Technical Bulletin

Pelican™ Protector 1.5 Inch Double-Throw Latch

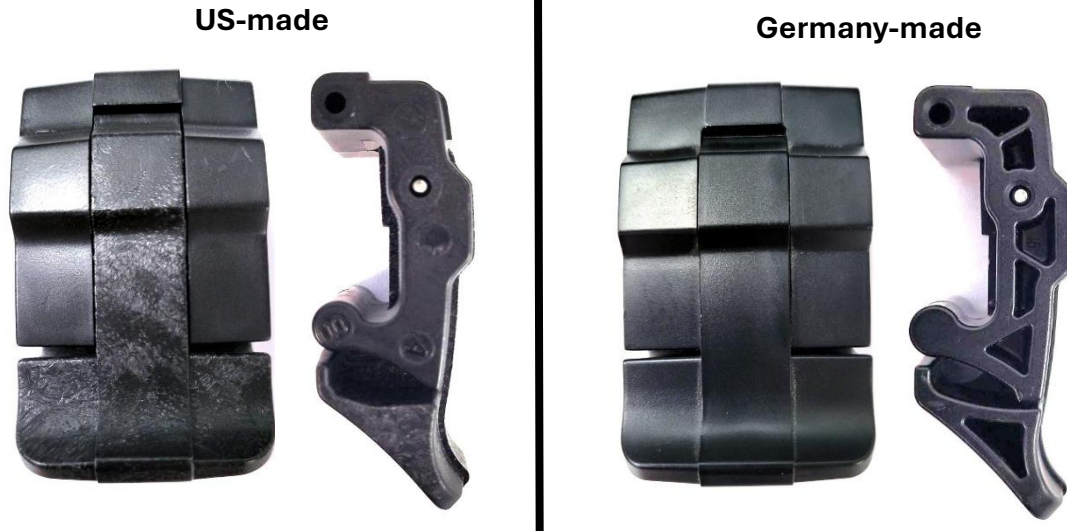
In the United States, the 1.5" double-throw latch is molded using two different materials. This results in a distinct, two-tone visual appearance, with each component having a visibly different finish. However in Germany, the same latch uses a single material giving it a uniform, single-tone appearance. Additionally, the German latch is cored out to reduce weight while maintaining its functional performance.

Despite the visual differences, there is no performance difference between the two versions. In the future, the US-made latch will transition to a similar single-material design using a new mold, aligning its appearance with the German version. The transition to a single-material design in the US and Germany will not impact the durability, fit or function.
